TB 171

TECHNICAL BULLETIN

Product : Midilift Piccolo

Subject : Cabin door release cable

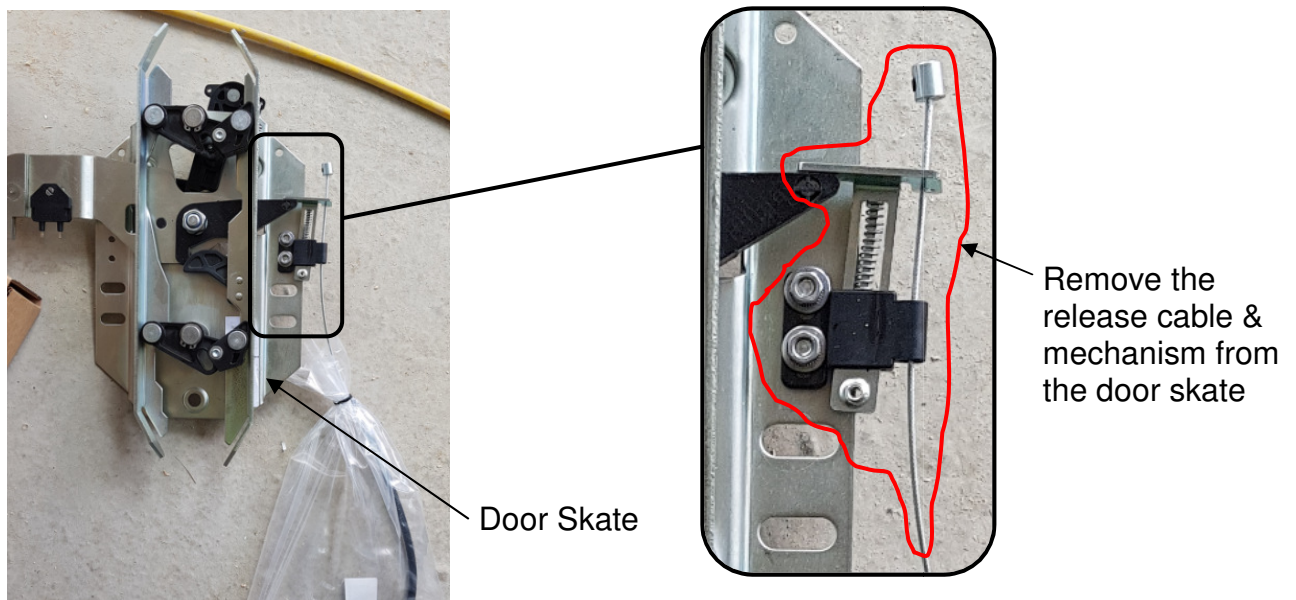
Fermator cabin door assemblies, used on Midilift Piccolos, are now being supplied with a release cable and mechanism pre-fitted to the door skate (see image). This permits the cabin doors to be opened from outside of the lift.

Whilst this may be considered a convenient feature, it could also give rise to a hazardous situation if anybody were to attempt to release trapped passengers when the lift is above floor level (i.e. passengers could exit the cabin and inadvertently fall through the gap between the cabin toeguard and the landing sill).

For this reason, Midilift Piccolo's **MUST NOT** be fitted with the cabin door release cable and mechanism.

Installation Engineers – remove the release cable and mechanism from the door skate

Service Engineers – inspect cabin door skate at next scheduled service visit and remove release cable and mechanism (if present)
